UNITED STATES PATENT AND TRADEMARK OFFICE

APPLICATION NO.	FILING DATE	FIRST NAMED INVENTOR	ATTORNEY DOCKET NO.	CONFIRMATION NO.
10/811,052	03/29/2004	Jeffrey John-Carl Tuttle		9520

Office Action Summary	Application No.	Applicant(s)	
	10/811,052	TUTTLE, JEFFREY JOHN-CARL	
	Examiner	Art Unit	
	Stephen L. Blau	3711

DETAILED ACTION

Enclosure (1)

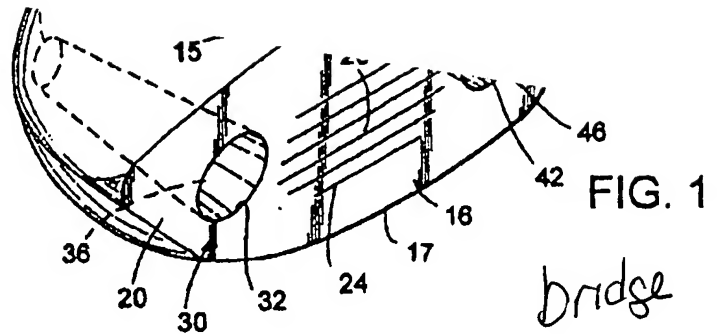
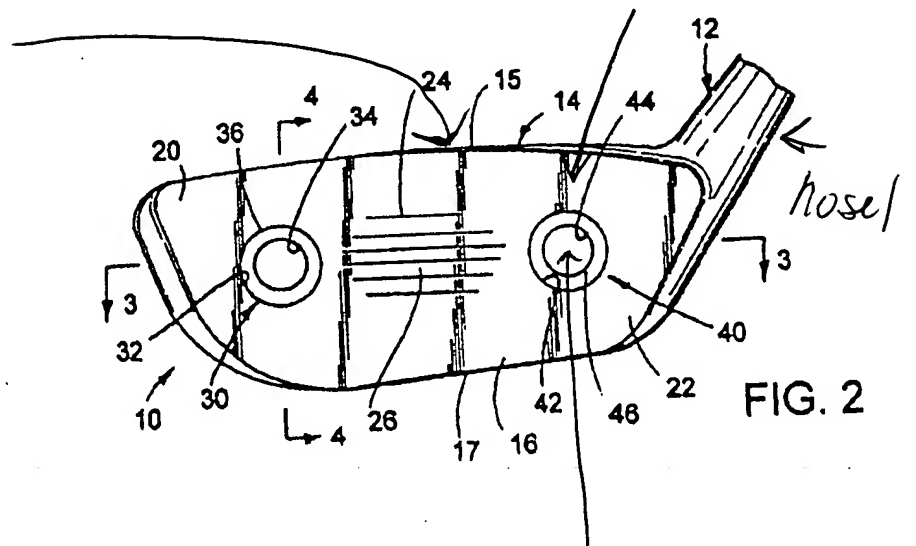
Thill discloses a wood type head having a hosel (12) extending generally upwardly from the heel end (Fig. 2), a hosel having at least one reinforcement bridge of material extending out from the hosel to the main body creating a roughly cylindrical space underneath the reinforcement bridge of no material and a hosel reinforcement bridge extending from a hosel to the upper surface of the head (See enclosure (1)).

Thill lacks a hosel having a generally upwardly open hosel bore. Saso discloses a hosel having a generally upwardly open hosel bore (Figs. 2, 5). In view of the publication of Saso it would have been obvious to modify the wood type head of Thill to have a hosel having a generally upwardly open hosel bore in order to secure a shaft inside the bore when assembling a club.

4. In order to overcome the prior art of record the examiner recommends adding the following at the end of claims 1 and 5 right before the punctuation mark of the period. (- wherein said club head comprises a wood-type club head in which the hosel reinforcement bridge extends from the hosel to the upper surface of the club head, wherein said bridge forms a protrusion from said upper surface with said space extending higher than said upper surface --). In addition, claims 2-4 and 6-9 would have to be canceled. If the examiner found no better art in an updated search than claims 1 and 5 would be allowable.
